SCI-823-0.00

S.R. 823 UNDER SHUMWAY HOLLOW ROAD

STRUCTURE TYPE STUDY SUBMITTAL

JULY 15, 2005

PRELIMINARY SITE PLAN - ALTERNATIVE 2
 BRIDGE NO. SC1-823-XXXX
 S.R. 823 UNDER SHUMWAY HOLLOW ROAD

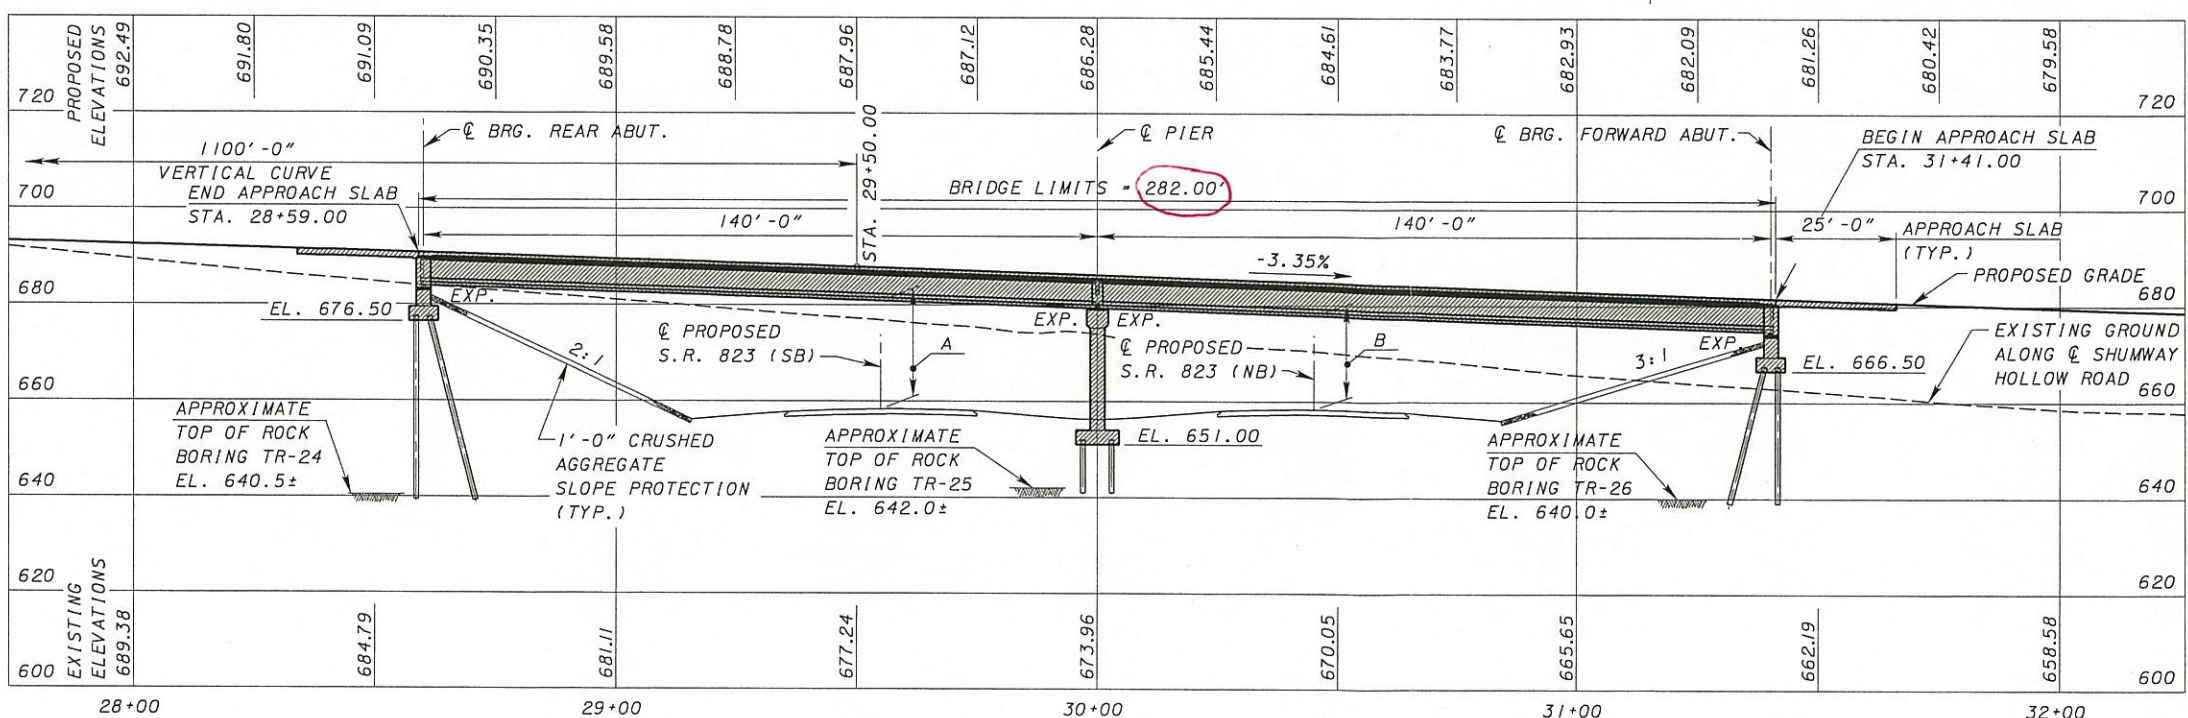
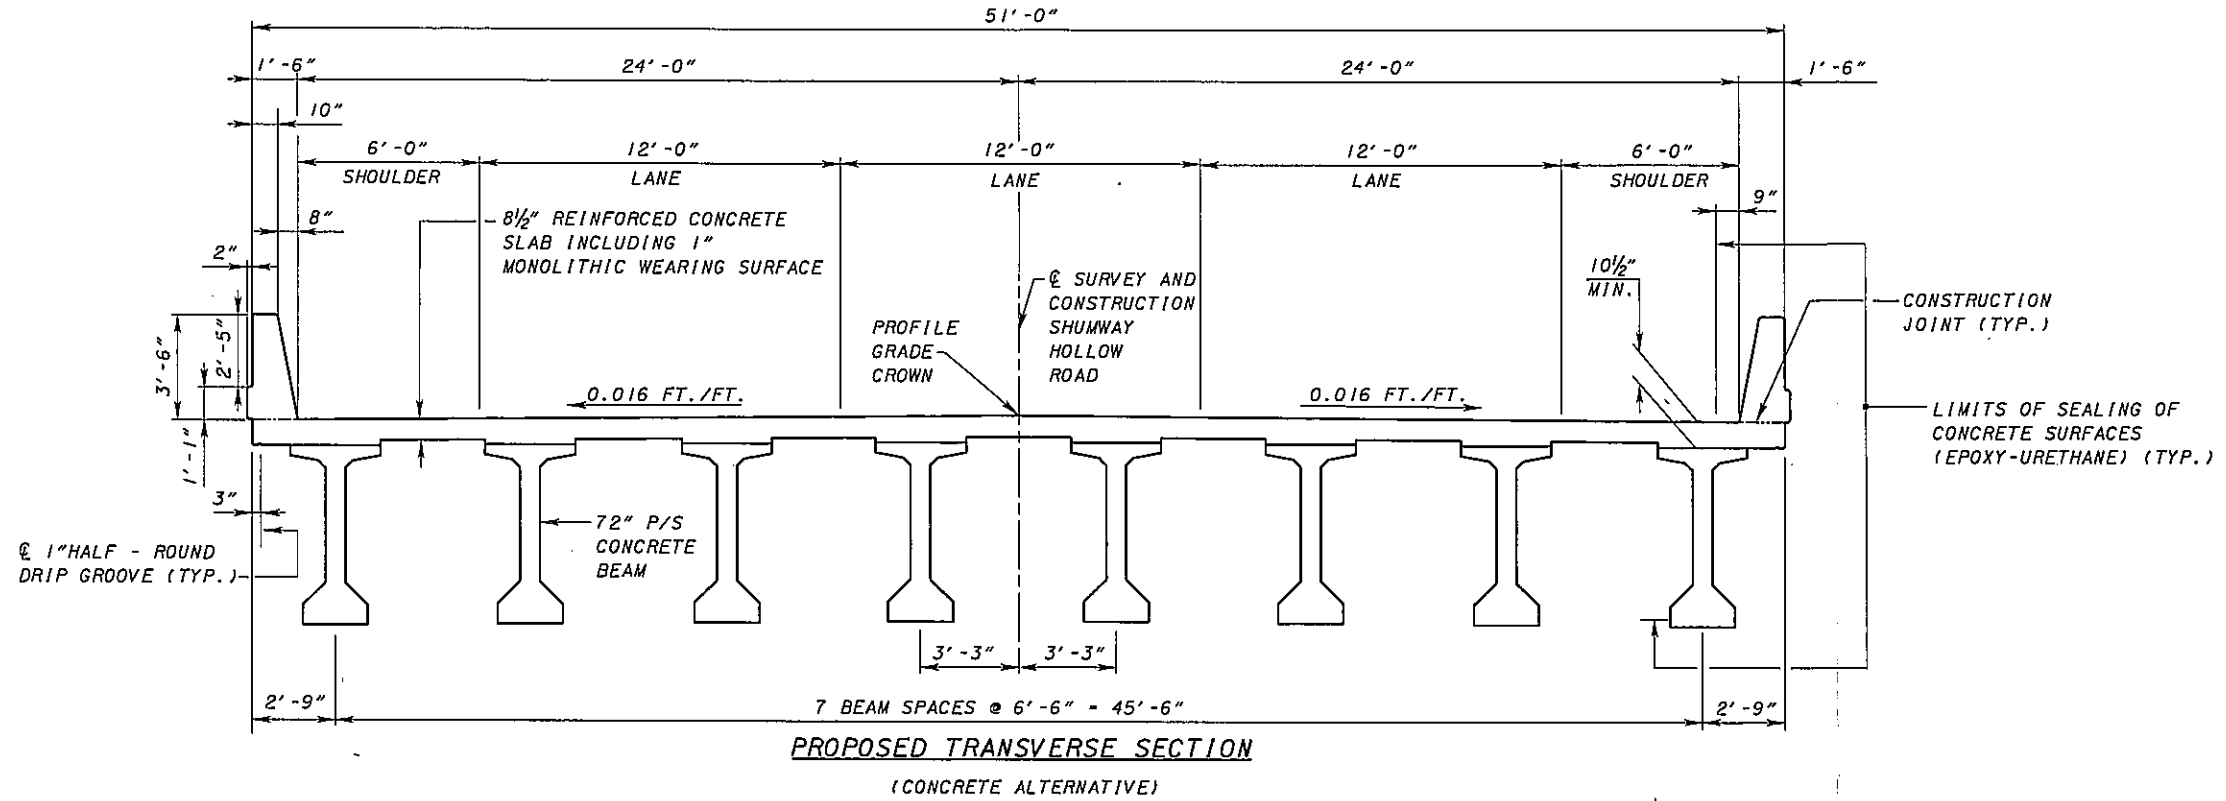
Can this be lowered?

Concrete strength
